SHEARON HARRIS NUCLEAR POWER PLANT, UNIT NO. 1
DOCKET NO. 50-400/RENEWED LICENSE NO. NPF-63
RESPONSE TO SECOND REQUEST FOR ADDITIONAL INFORMATION
REGARDING AMENDMENT TO REMOVE CREDIT FOR BORAFLEX IN
BOILING-WATER REACTOR SPENT FUEL POOL STORAGE RACKS
(TAC NO. ME0012)

SHEARON HARRIS NUCLEAR POWER PLANT, UNIT NO. 1
DOCKET NO. 50-400/RENEWED LICENSE NO. NPF-63
RESPONSE TO SECOND REQUEST FOR ADDITIONAL INFORMATION

Figure 1: The reactivity impact of the modeling assumption (Response 4.c)

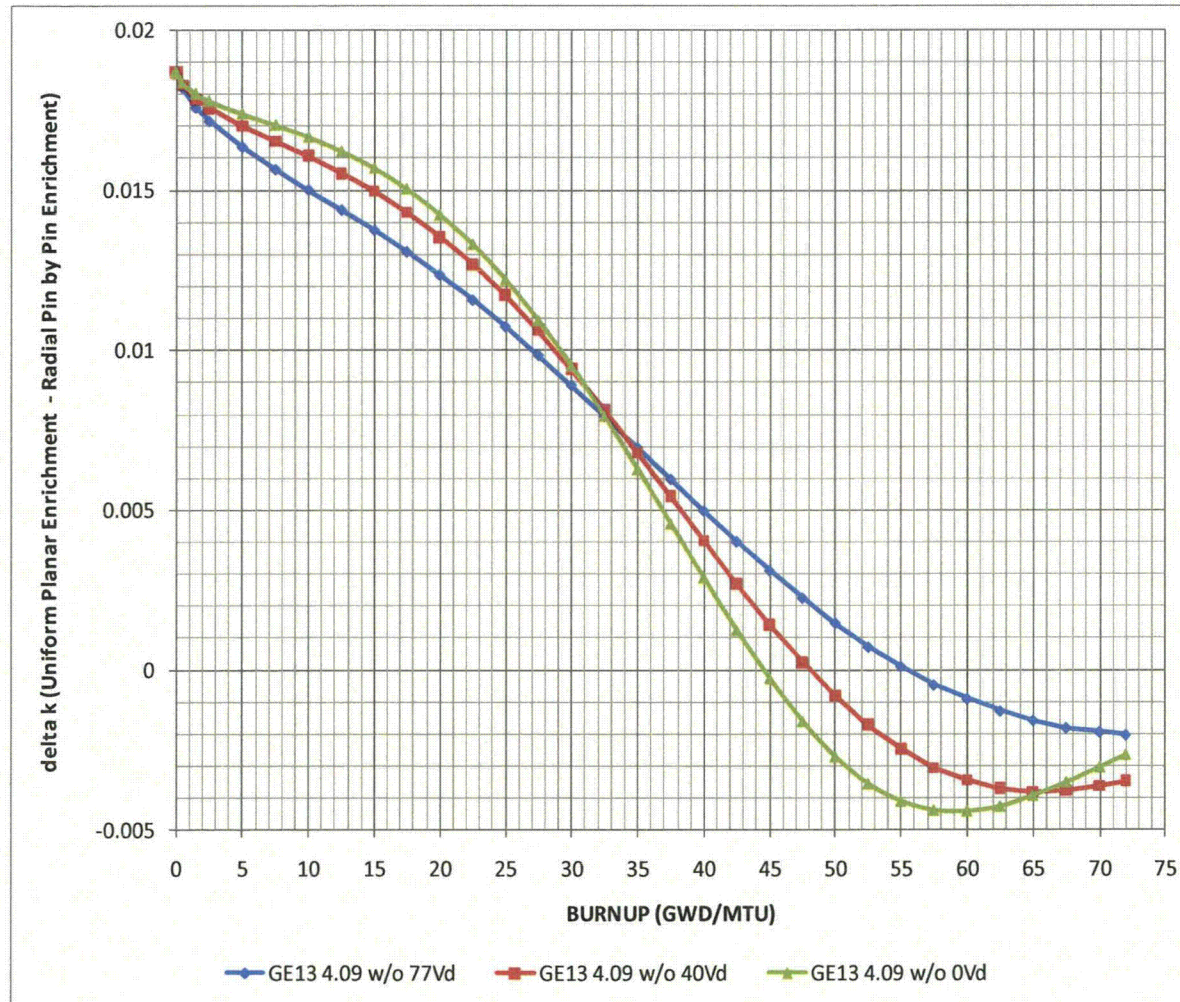
- c. The analysis uses an average enrichment for each plane rather than the detailed pin-by-pin enrichment distribution. Provide a justification for this modeling simplification. If appropriate, include bias and uncertainty associated with the modeling simplification.

Response: The modeling simplification using an average enrichment for each plane rather than the detailed pin-by-pin enrichment is justified because it is a conservative modeling simplification for BWR fuel assemblies stored in the Harris spent fuel pools. This modeling simplification has previously been reported as conservative for both BWR (i.e., Response to Request for Additional Information No. 27 in AREVA Report ANP-2843Q1NP, ADAMS Accession Number ML101650230) and PWR fuel lattices (i.e., Appendix B.2.1 of AREVA Report ANP-2779-001, ADAMS Accession Number ML083360624).

The reactivity impact of this modeling assumption is also shown as Figure 1 in the Attachment to this Enclosure for the highest planar enrichment GE13 lattice utilized in the highest burnup BWR fuel assembly stored in any Harris spent fuel pool, except that no Gd was included in the model. The calculations were performed with CASMO-4 in the rack geometry following depletion in the core geometry. The results show modeling an average planar enrichment rather than the detailed pin-by-pin enrichment is conservative through fuel burnups of approximately 45 GWD/MTU, which is the highest burnup of any BWR assembly in any Harris spent fuel pool. Since there are no plans to receive additional BWR fuel shipments for storage in the HNP fuels, analysis to this 45 GWD/MTU value is realistic and bounding.

The results do show uniform enrichment can become negligibly non-conservative by 45 GWD/MTU assuming depletion at 0 percent void history. However, the analysis supporting the burnup credit loading curves assumes all nodes deplete at 77 percent void history. The response to Request 9 shows modeling fuel that actually depletes at 0 percent void history as depleting at 77 percent void history is significantly and increasingly conservative with increasing burnup. It should also be noted that only the lower assembly nodes deplete at 0 percent void history in a BWR.

Figure 2: In-rack CASMO-4 calculation results for 0 percent void history (Response 7)

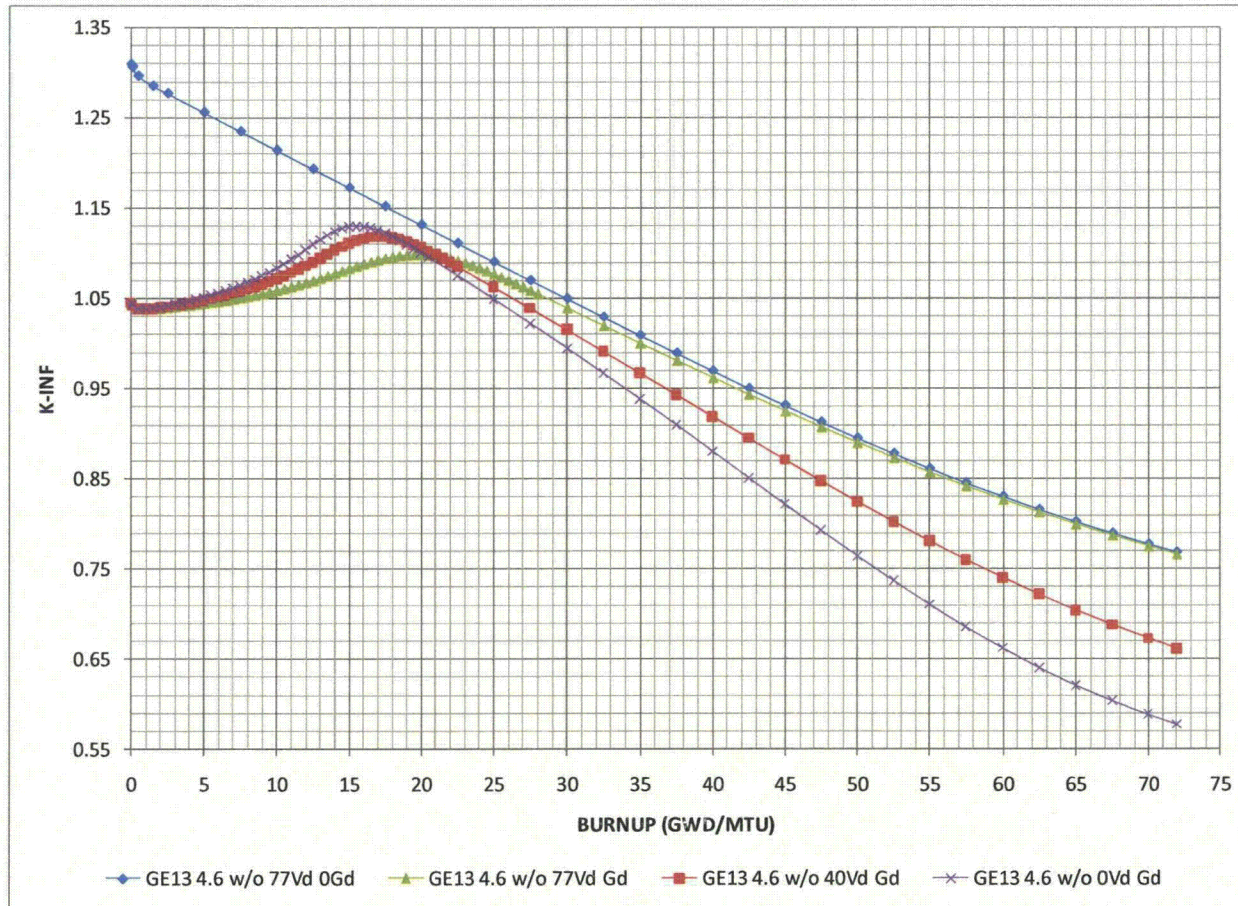
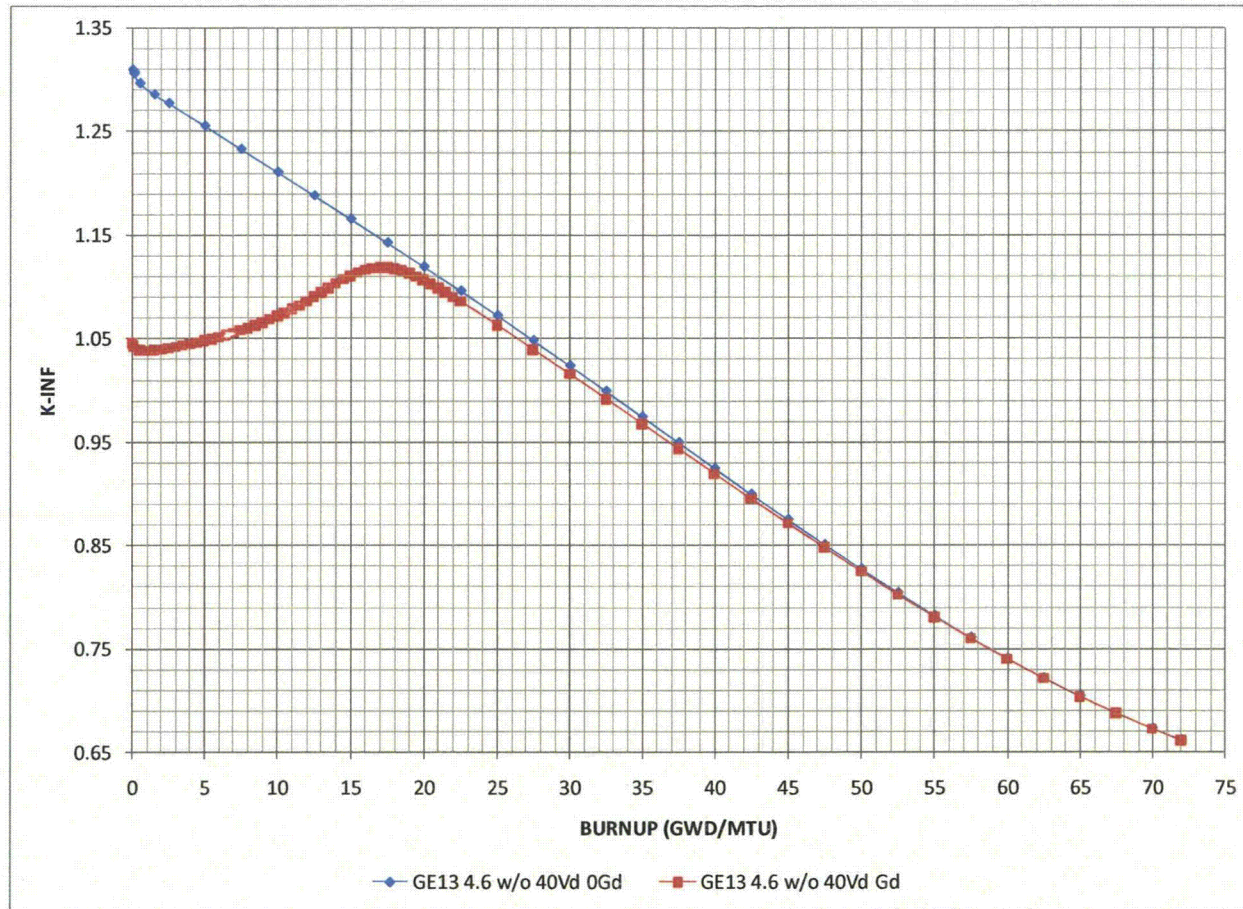
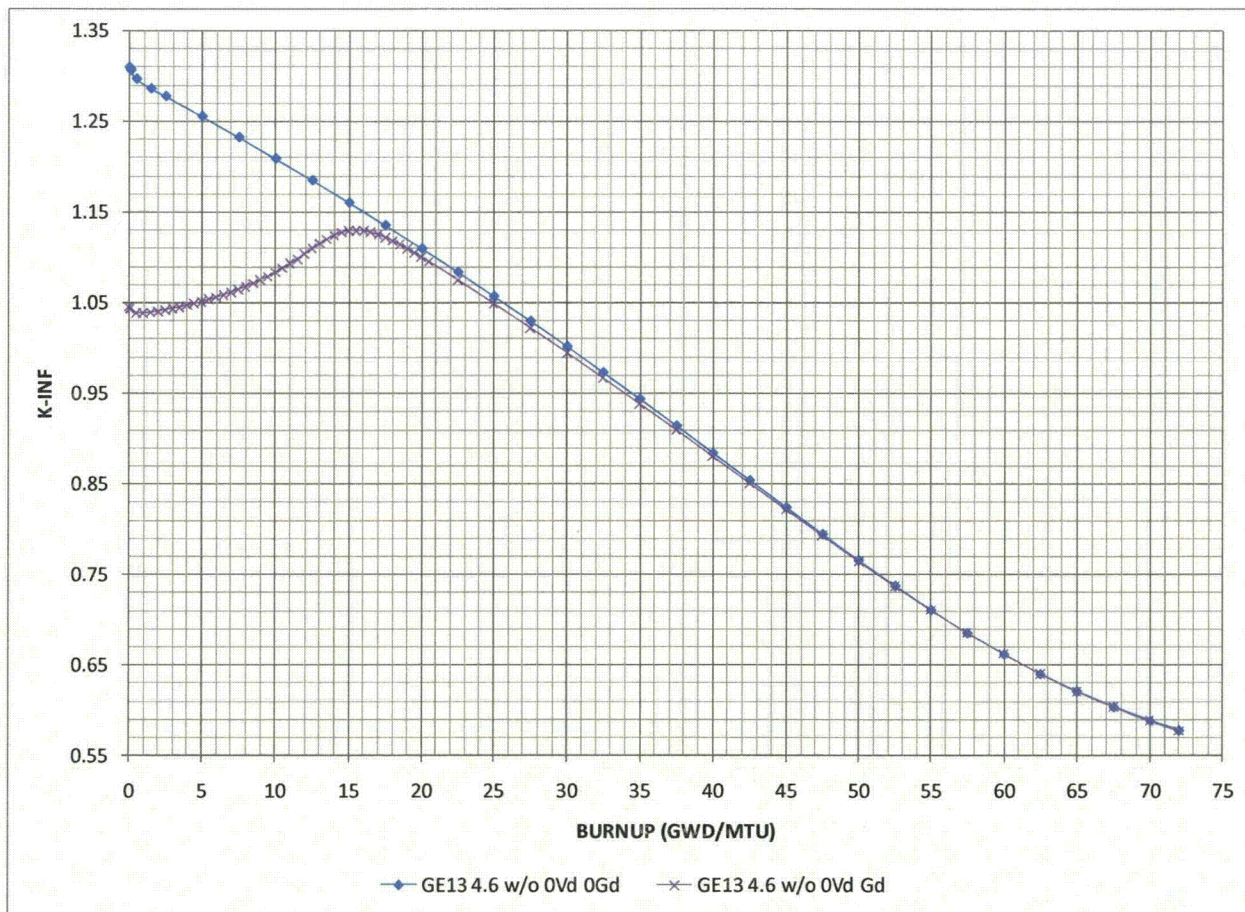
This issue was raised in earlier requests for additional information (RAIs); the response provided in Enclosure 1 to the licensee's supplemental letter dated January 18, 2010, and its Attachment 1 has been reviewed. The information provided does not fully address the issue. The calculations documented in the RAI response were performed with CASMO-4, a two-dimensional (2D) lattice code. This calculational approach does not address the impact of axially dependent design features such as blankets, part-length rods, axial zoning of Gd, and, if utilized, axial zoning of fuel ^{235}U enrichments.

Further, the RAI response notes that "representative Gadolinium loading and location of Gadolinium rods were used." A three-dimensional (3D) analysis should be performed using gadolinium rod loading and radial and axial locations that are expected to cover the range of acceptable configurations. Provide additional justification supporting the assertion that neglecting gadolinium is a conservative simplification.

Response: Gd displaces fissionable fuel. Uranium oxide fuel poisoned with Gadolinium oxide has lower density than equivalent fuel that contains no Gd, because Gadolinium oxide is less dense than Uranium oxide. Gd poisoned fuel containing the same weight percent ^{235}U enrichment as unpoisoned fuel also contains less total fissionable ^{235}U due to its lower density. Gd does not convert to fissionable isotopes by neutron capture. Additionally, fuel poisoned with Gd incurs a small residual reactivity penalty due to conversion of the highly absorbing ^{155}Gd and ^{157}Gd isotopes to ^{156}Gd and ^{158}Gd via neutron capture. The absorption cross sections of ^{156}Gd and ^{158}Gd are small, but nonetheless produce a small residual reactivity penalty that diminishes very slowly with fuel burnup.

Depletion of a Gd poisoned fuel lattice at different void histories will show that depletion at zero void history results in greater reactivity at the relatively low burnup associated with peak reactivity. This is due to the increased thermal flux at zero void history depleting Gd before the competing effect of higher plutonium production at higher void dominates at increased exposure. However, a Gd poisoned lattice will not become more reactive than one of equal ^{235}U weight-percent enrichment that is not poisoned since Gd displaces fissionable fuel, does not convert to fissionable fuel via neutron capture and imparts a small residual reactivity penalty to the fuel.

Fuel geometry and specific depletion characteristics do not affect the characteristics of Gd as a burnable absorber (i.e., Gd displaces fissionable fuel, does not convert to fissionable fuel via neutron capture and imparts a residual reactivity penalty to the fuel). For this reason, it is not necessary to explicitly calculate these characteristics for different fuel geometries or depletion characteristics in detail. In-rack CASMO-4 calculation results are presented in Figures 2 through 4 of the Attachment to this Enclosure for 0-, 40- and 77-percent void history depletions for a GE13 lattice of uniform 4.6 weight-percent enrichment containing 11 Gd rods at 5 weight-percent Gd for the purpose of illustrating the trends discussed above.

FIGURE 5.6-3
POOLS "A" AND "B" BURNUP VERSUS ENRICHMENT FOR BWR BORAFLEX RACKS

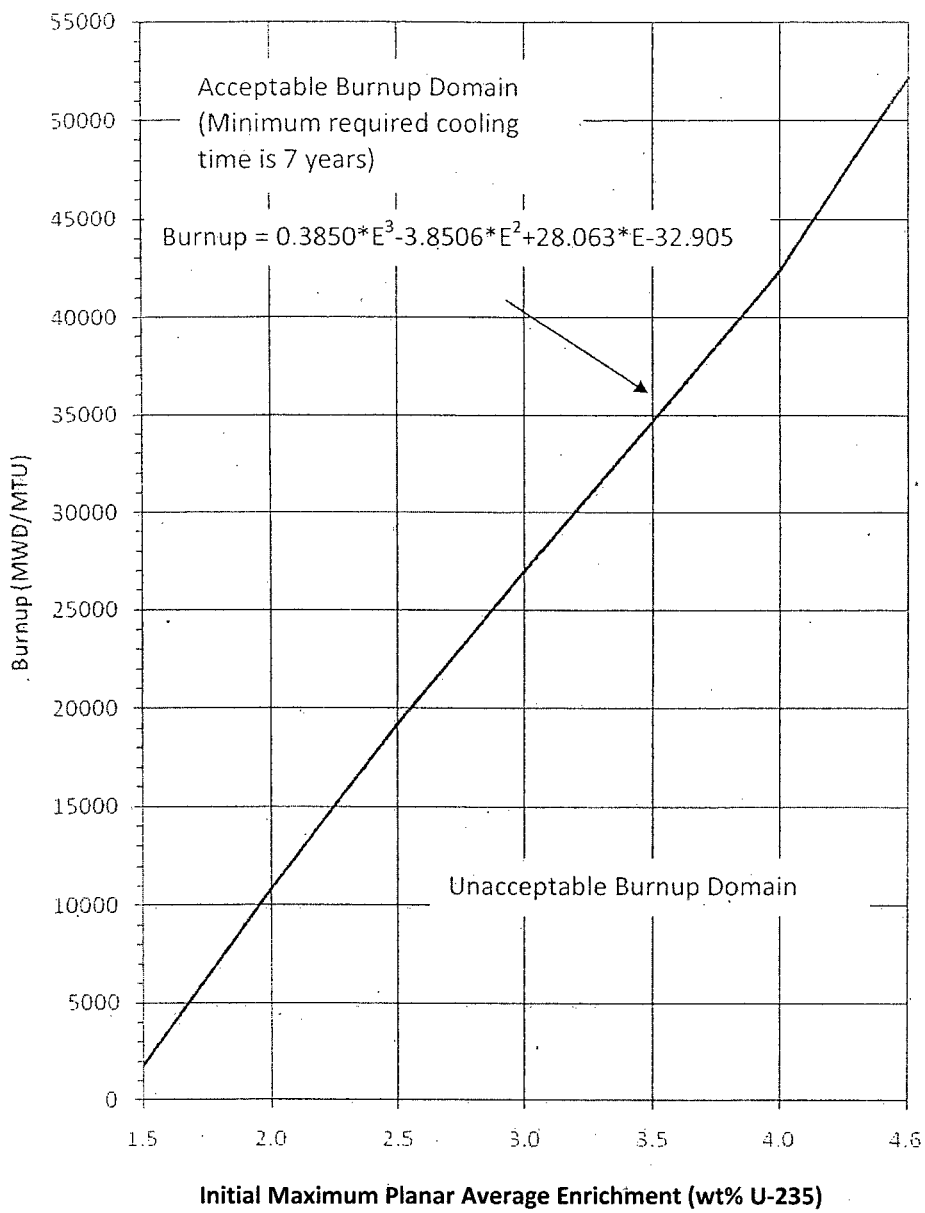
- c. TS Figure 5.6-3 should specify "Initial Maximum Planar Average Enrichment (wt% U-235)" instead of just "Enrichment." Having just "Enrichment" might be confused with assembly average enrichment.

Response: The x-axis title for Tech Spec figure 5.6-3 will be changed to incorporate this recommendation.
